product modification

040-0487-02

LEAD TIME

For TEKTRONIX® 284 Pulse Generator

Fig. 1. Mounting bracket installation.

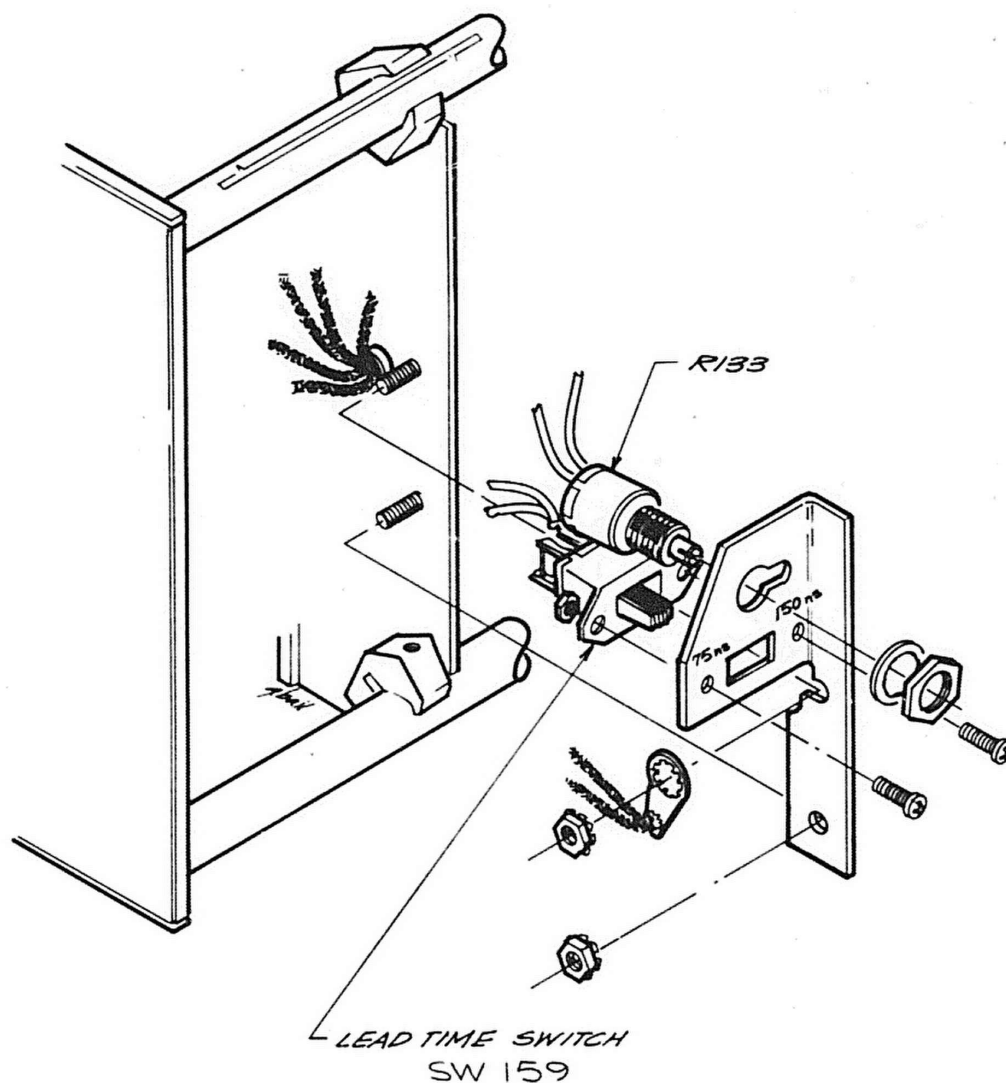
- () 21. Secure the left-side (looking from front) of the delay line assembly with two of the 4-40 nuts provided in the kit.
- () 22. Install the provided switch assembly onto the two right-side mounting studs of the delay line assembly, as shown in Fig. 1.

- () 23. Install the provided lug terminal onto the top-right delay line mounting stud. See Fig. 1.

- () 24. Secure the new switch assembly to the support chassis with two of the provided 4-40 nuts.
- () 25. Install the variable resistor, R133 (if present), into the hole above the 75ns-150ns Lead Time switch, SW159, in the new mounting bracket.

Fig. 2. Wiring for new Lead Time switch, SW159.

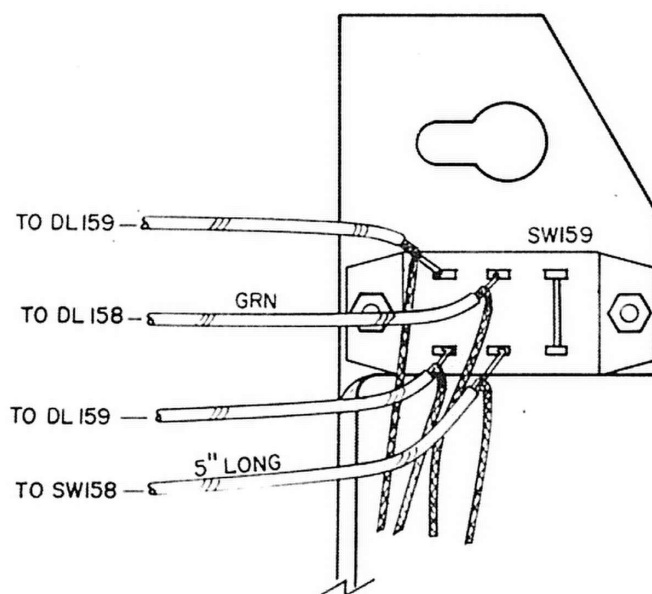
- () 29. Solder the shields of the two coaxial cables, connected to SW158 in the preceeding steps, to the ground lug terminal adjacent to SW158.
- () 30. Solder the center conductor of the other green delay line coaxial cable to the top center terminal of the new 75ns - 150ns Test Lead switch, SW159. See Fig. 2.

- () 31. Solder the center conductor of the added 5 inch coaxial cable (see step 28 above) to the bottom center terminal of the Test Lead switch, SW159. See Fig. 2.

- () 32. Solder the center conductor of one of the two remaining delay line coaxial leads to the bottom rear terminal of the new Test Lead switch, SW159. See Fig. 2.

- () 33. Solder the center conductor of the remaining delay line coaxial lead to top rear terminal of the Test Lead switch, SW159. See Fig. 2.
- () 34. Solder the shields of the four coaxial cables, connected to SW159 in the preceding steps, to the ground lug terminal below the switch. The terminal was added in step 23.

Partial - PULSE GENERATOR

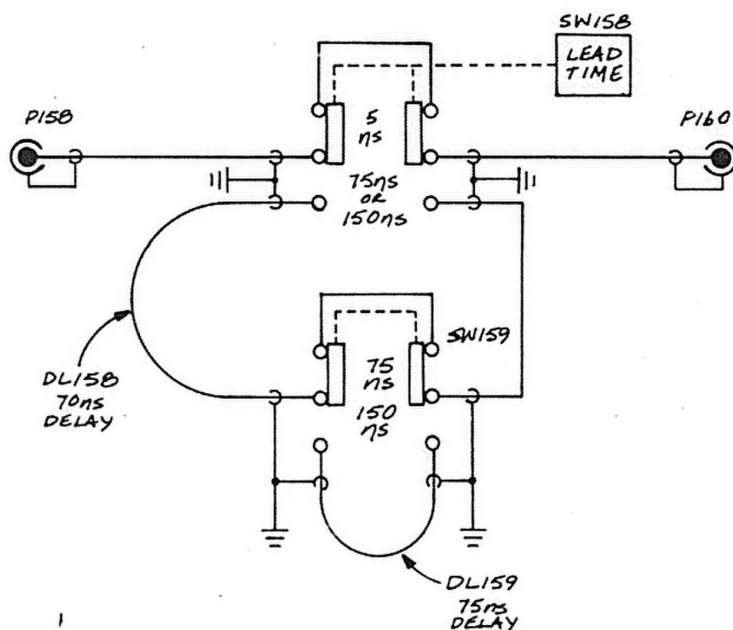
This modification kit allowed the maximum lead time for the Trigger Output signal to be selected. The maximum Lead Time is now selected internally by a new two-position switch as either 75ns or 150ns. The front panel LEAD TIME switch remains a two-position switch selecting 5ns in one position and 75ns or 150ns in the other position, depending upon the position of the internal switch. In order to accomplish this modification, the delay line, DL158, was replaced, a new switch was mounted on the support chassis, and the front panel was replaced.

Ckt. No.	Part Number	Description
C156	283-0603-00	Capacitor, mica, 113pF, 2 pct, 300V
DL158 DL159	119-0146-03	Delay line, elec, 145ns w/70ns tap, 50 Ω
SW159	260-1833-00	Switch, slide, DPDT, 0.05A, 125V
